UNITED STATES PATENT AND TRADEMARK OFFICE

APPLICATION NO.	FILING DATE	FIRST NAMED INVENTOR	ATTORNEY DOCKET NO.	CONFIRMATION NO.
10/660,438	09/11/2003	Branko D. Kovacevic	1376-0200220	7502
34456 7590 04/15/2008 LARSON NEWMAN ABEL POLANSKY & WHITE, LLP 5914 WEST COURTYARD DRIVE SUITE 200 AUSTIN, TX 78730				
EXAMINER				
BUL, BRYAN P				
ART UNIT		PAPER NUMBER		
2153				
MAIL DATE		DELIVERY MODE		
04/15/2008		PAPER

Office Action Summary

DETAILED ACTION

FIG. 1

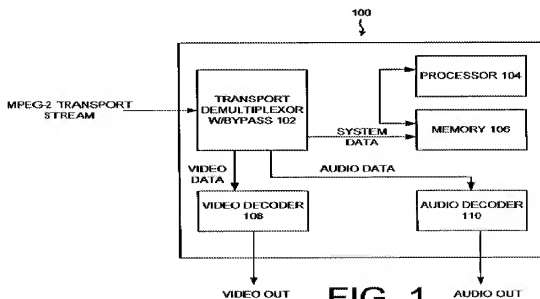
determining, based upon a first portion of the first data stream, the first protocol of the multimedia data (see col. 7, lines 21-33 together with Fig. 1&2: **Transport Demultiplexor W/BYPASS 102**)

FIG. 3

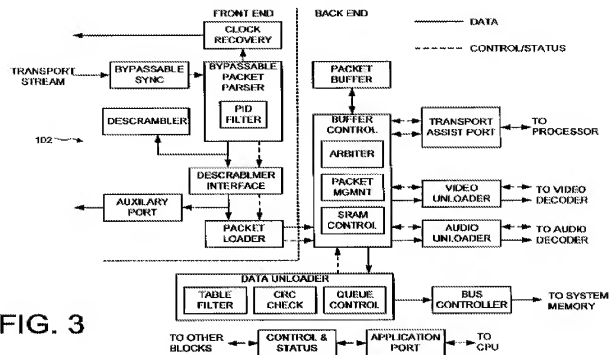
Regarding claim 13, Anderson discloses “the memory includes a frame buffer” (see Fig. 3, Packet Buffer and Buffer Control).

**FIG. 2****Conclusion**

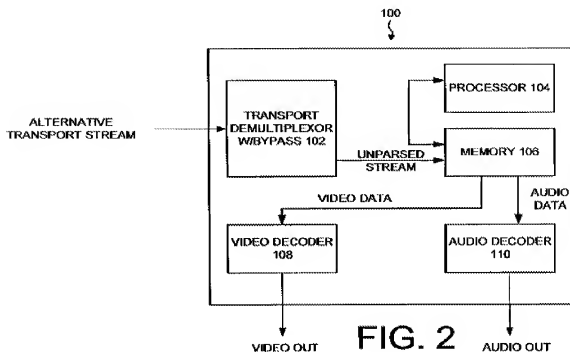
Regarding claim 14, Anderson discloses the claimed features “receiving a second data stream of multimedia data, different from the first data stream, wherein the multimedia data of the second data stream includes a second protocol, different from the first protocol and further wherein the second protocol is unknown” and “determining, based upon a first portion of the second data stream, the second protocol of the multimedia data of the second data stream” (see col. 8, lines 6-22 and Fig. 2: Alternative Transport Stream).
